Office Action Summary	Application No. 10/828,993	Applicant(s) HUGGINS, HAROLD ALEXIS	
	Examiner Angela M. Lie	Art Unit 2163

DETAILED ACTION

3. **Claims 29, 35-37 and 40 are rejected under 35 U.S.C. 102(e) as being anticipated by Sridharan et al (US Patent No. 6525623).**

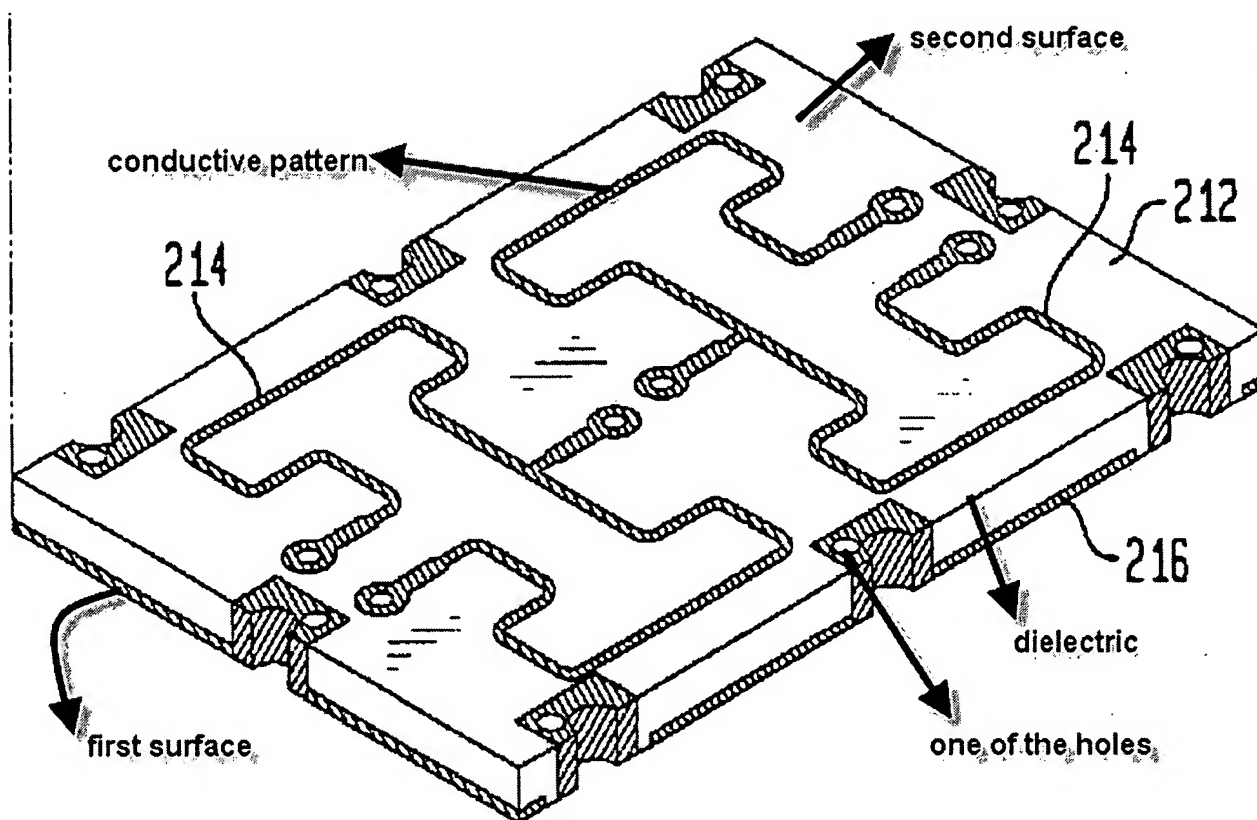
As to claim 29, Sridharan discloses a radio frequency (RF) component comprising: a dielectric layer (Figure 9, element 212) having opposing first (Figure 9, bottom side) and second major surface (as indicated in the figure below) being free from a semiconductor substrate, the dielectric layer (Figure 9, element 212) having a plurality of openings (as indicated in the figure below) between the first and second opposing major surfaces; and a patterned conductive (Figure 9, as indicated below) layer on the second major surface of the dielectric layer, wherein the plurality of openings are

arranged in a predetermined pattern along laterally opposing sides of the patterned conductive layer (as shown in figure below).

As to claim 35, Sridharan discloses the RF component wherein the plurality of openings are laterally adjacent portions of the patterned conductive layer with no openings extending through the patterned conductive layer (as shown in the figure above the holes adjacent to the edges (as indicated in the drawings above) are not extending through the patterned conductive layer.

As to claim 36, Sridharan discloses the RF component wherein each of the plurality of openings is cylindrically shaped (as shown in figure above).

As to claim 37, Srindharan discloses the RF component wherein there is substantially uniform spacing between the adjacent openings on each of the opposing sides of the patterned conductive layer (as shown in the figure above the spacing between holes is uniform).

8. With respect to the applicant's assertion on page 4, third paragraph alleging that "Sridharan does not teach a dielectric layer having opposing first and second major, the first surface being free from a semiconductor substrate", the examiner disagrees. As indicated in the rejection above, the figure shown above clearly illustrates dielectric layer having two surfaces with through holes, wherein first surface is free from a semiconductor.
